**GOVERNMENT OF THE DISTRICT OF COLUMBIA
DEPARTMENT OF TRANSPORTATION**

MEMORANDUM

SUBJECT: DDOT Review of BZA Case #18533, 1827 Adams Mill Road, NW

Figure 1: Proposed Site Layout and Access.

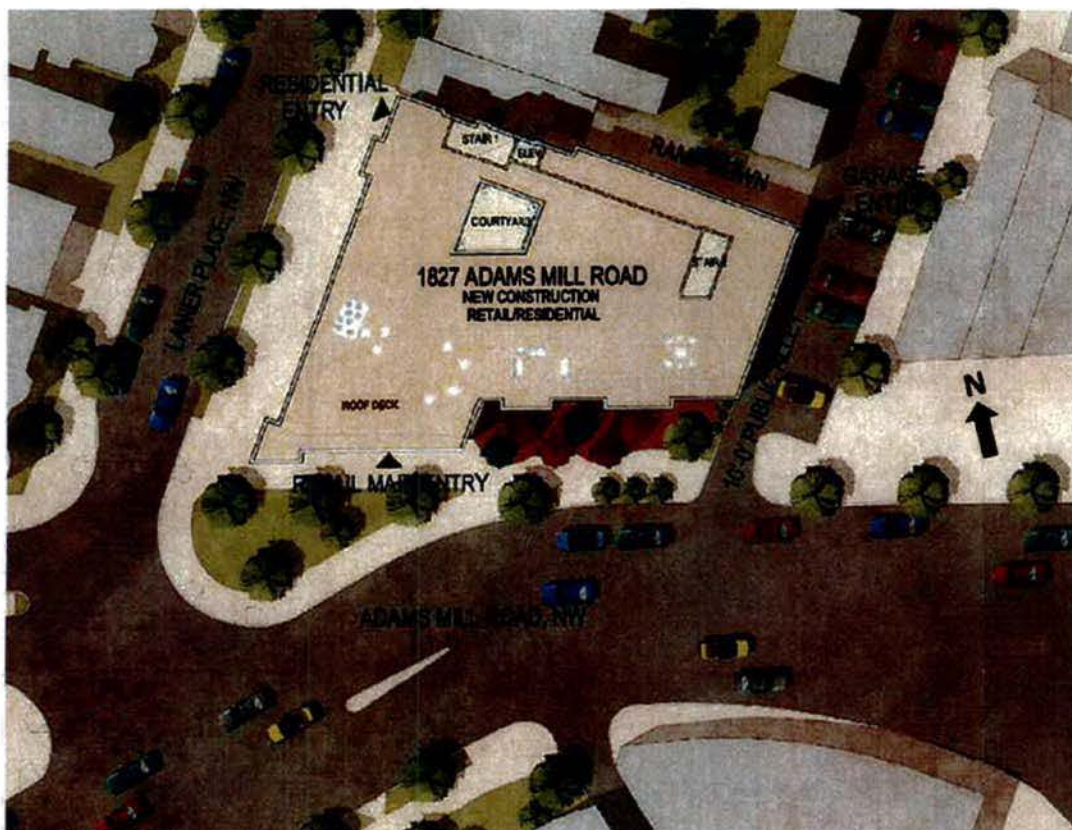
The residential and retail entries provide pedestrian access from Lanier Place and Adams Mill Road, respectively. The garage entry, located off of the north-south public alley, serves long-term bicycle parking, passenger vehicle parking, loading, and trash pick-up. The Applicant has proposed removing all driveway entry points that serve the existing gas station. Currently, there is an access driveway along Adams Mill Road and along Lanier Place. All future vehicle access is proposed from a new access point located off of the north-south public alley that abuts the east side of the property.
